# Origination Form

## Proposed Revisions to a Standard Plans Index

<b>Originator:</b>	Turley, Joshua	<b>Index Number:</b>	521-660
<b>Date:</b>	5/14/2024	<b>Sheet Number(s):</b>	2, 4
<b>E-mail:</b>	Joshua.Turley@dot.state.fl.us	<b>Index Title:</b>	LIGHT POLE PEDESTAL - BRIDGE

OPTION 2 - TYPICAL SECTION AT LIGHT POLE PEDESTAL (Approach Slab Similar)

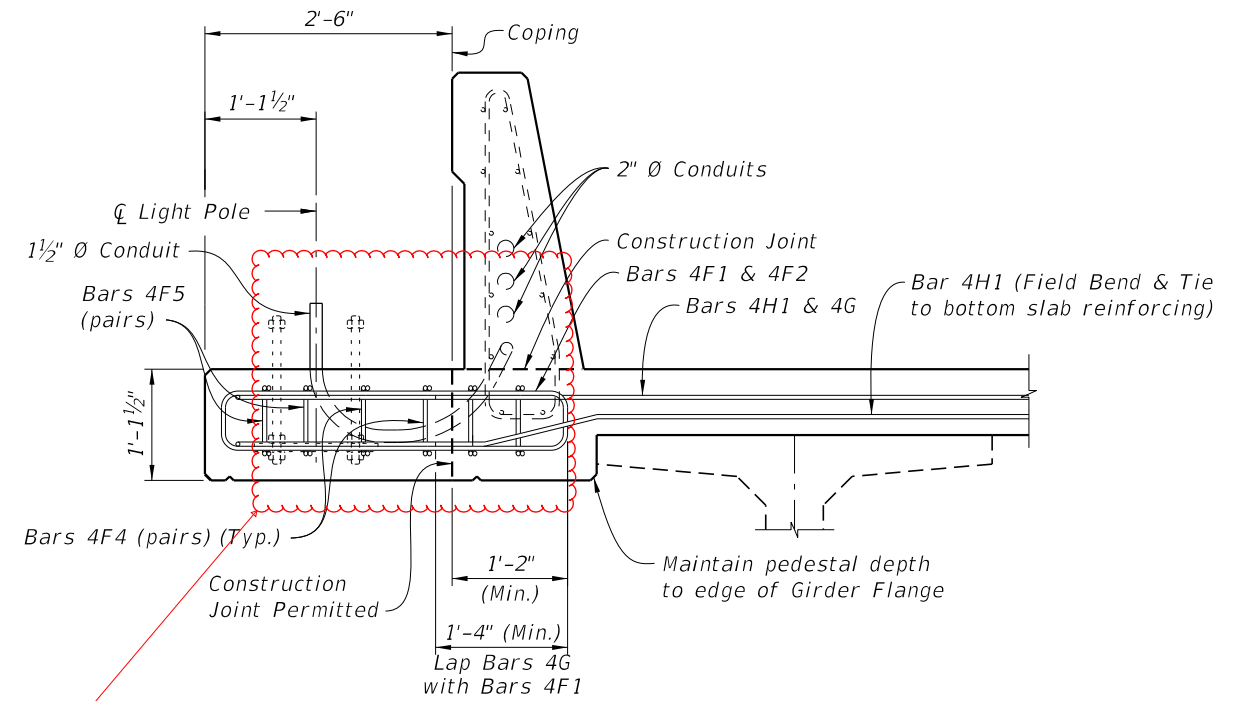
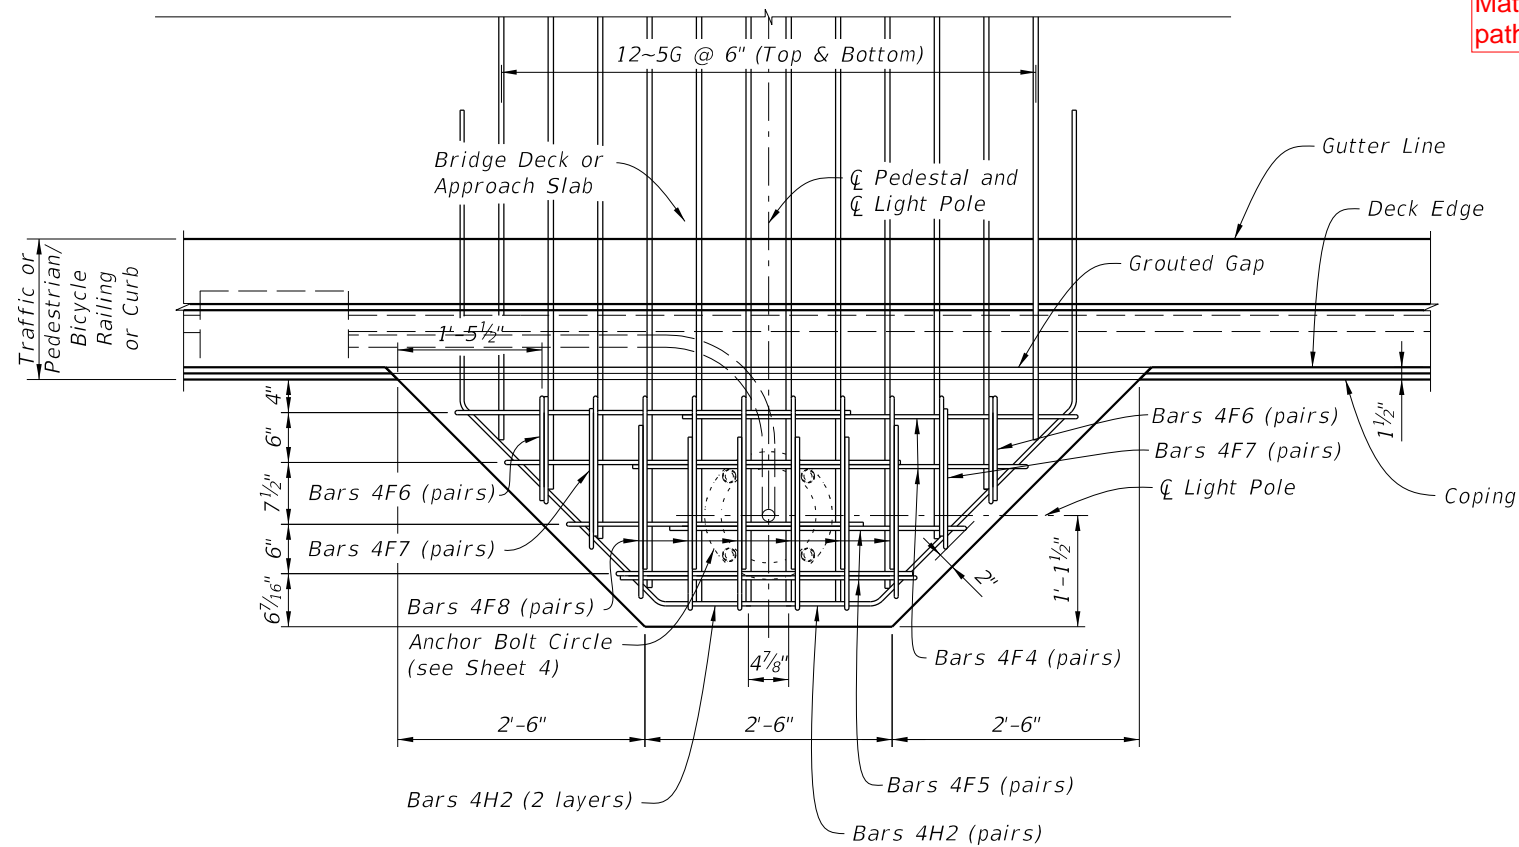
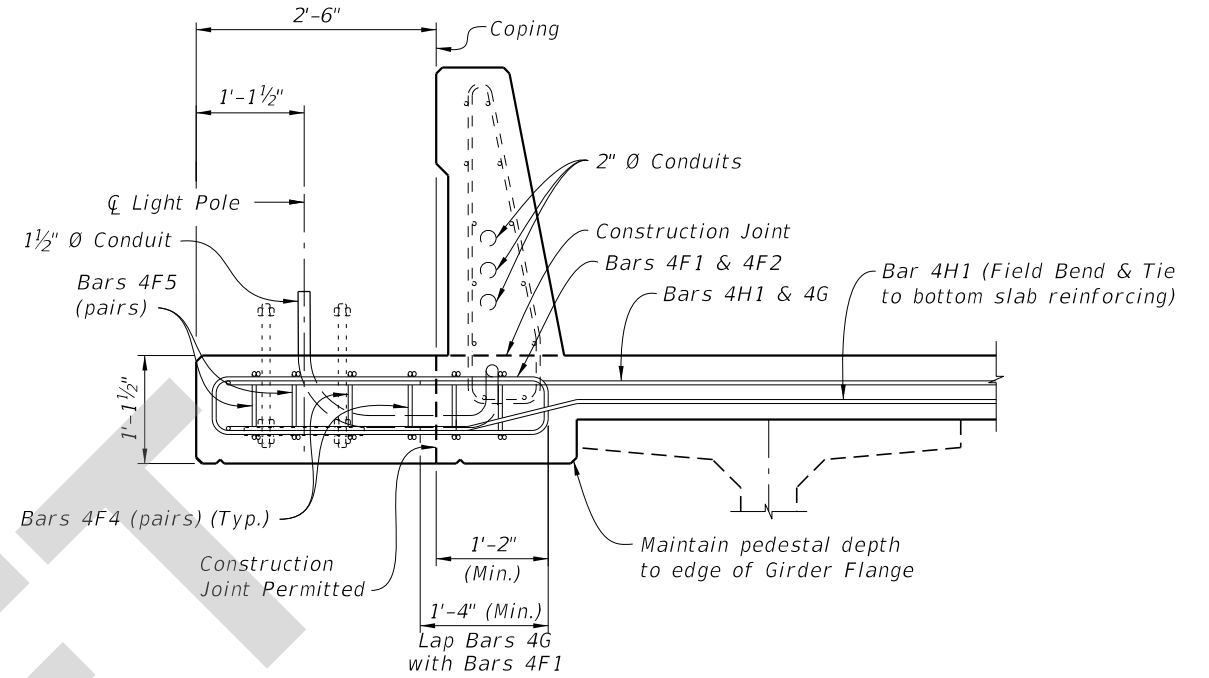
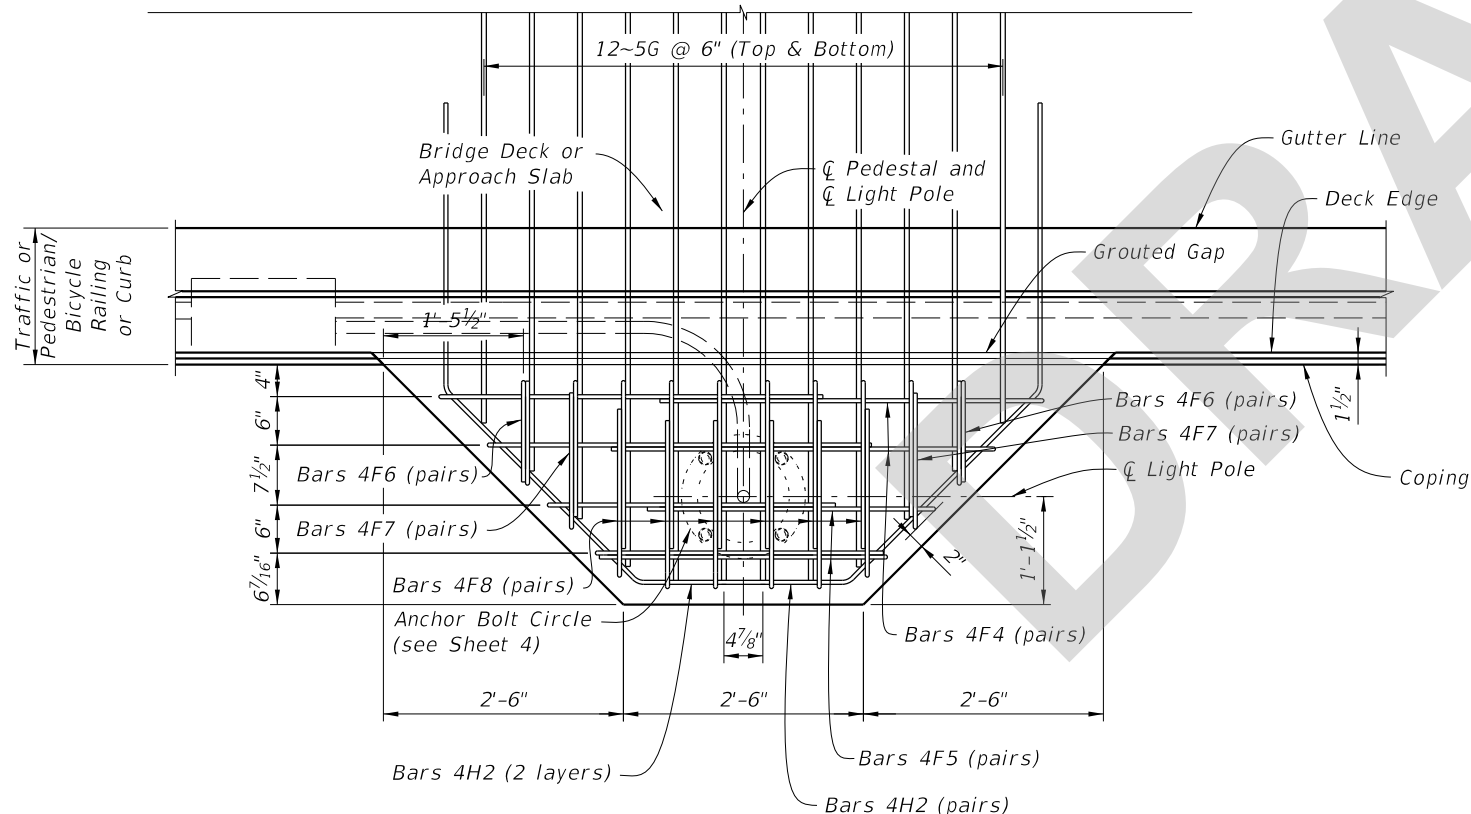
Sheet 2: Revised conduit path for the TYPICAL SECTION's.  
 Sheet 4: Labeled the anchor bolt nuts in DETAIL "A"; Removed the anchor bolt table and updated corresponding notes. Added "Note: Min. anchor bolt embed is 9 1/2". Max embed must maintain min. required bottom cover. Anchor bolt; embed max. may be as long as required for constructability depending on which pedestal option is used."

Match the conduit curvature path of sheet 1 option 1.

Sheet 1: Conduit path was slightly incorrect so we fixed it.  
 Sheet 4: The anchor bolt nuts were labled to correspond with the Spec. The anchor bolt table was removed so that this Index will only address the standardized pole and pedestal capacities. The pole mounting height is limited to 40 feet for an elevated structure mount.
